CALIFORNIA COASTAL COMMISSION

ADDENDUM

DATE: August 12, 2014
TO: Commissioners and Interested Parties
FROM: South Central Coast District Staff
SUBJECT: Agenda Item Th9a&10a, Major Amendment No. LRDP-4-UCS-14-0002-1 and Notice of Impending Development (NOID) UCS-NOID-0005-14 –University of California at Santa Barbara (UCSB) Thursday, August 14, 2014.

SUBJECT: **Proposed Major Amendment No. LRDP-4-UCS-14-0002-1 to the University of California Santa Barbara Certified Long Range Development Plan (LRDP) and Notice of Impending Development (NOID) UCS-NOID-0005-14** for the Kavli Institution for Theoretical Physics Housing Project, for Public Hearing and Commission Action at the August 14, 2014 Commission Meeting in San Diego.

Exhibit 10
Certified LRDP Figure 23 Storke Campus Plan
LRDP-4-UCS-14-0002-1 &
UCS-NOID-0005-14

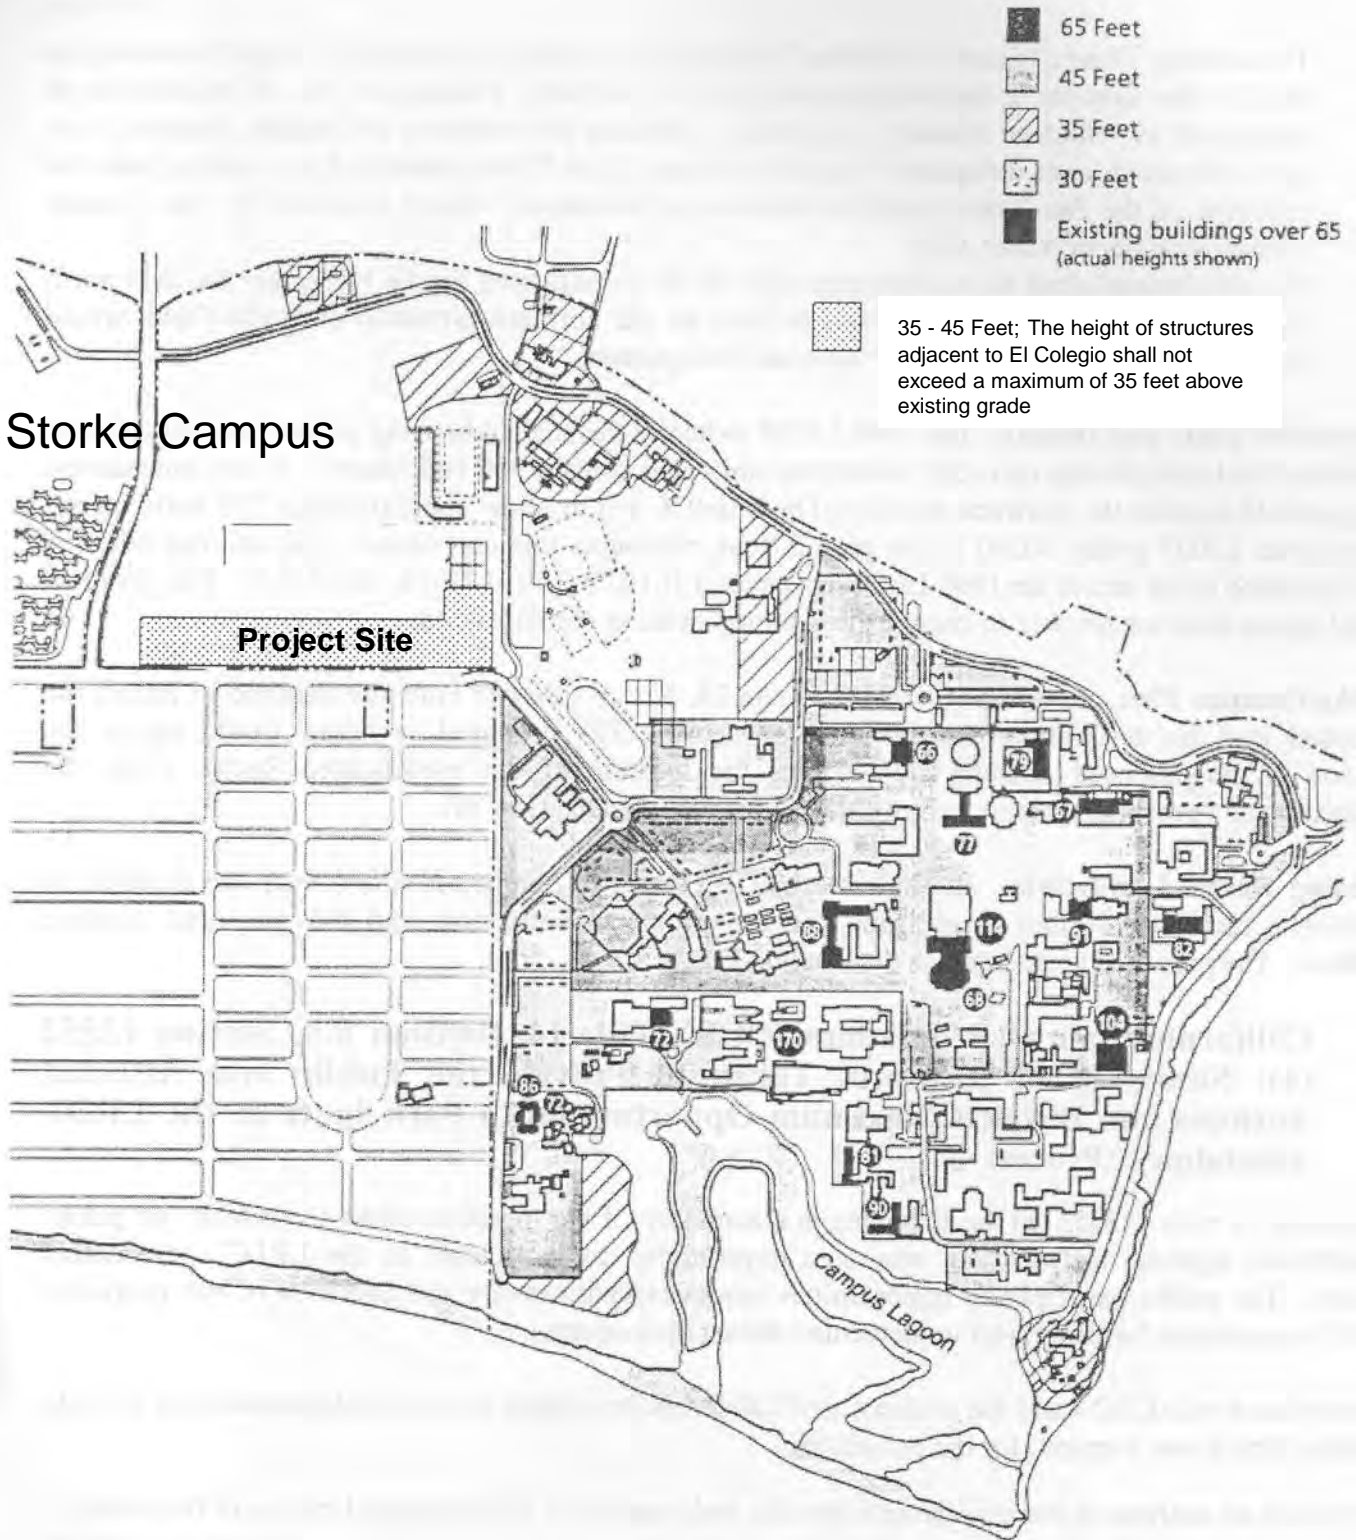
Policy 30240(b).14a: Development at the Kavli Institute of Theoretical Physics Housing site shall be located ~~within the~~ on an approximately ~~one~~ 1.5-acre potential development area within the 11.5-acre development envelope designated as Student Housing on certified Figure 23 Storke Campus Plan D-3 and shall be consistent with the following build-out provisions:
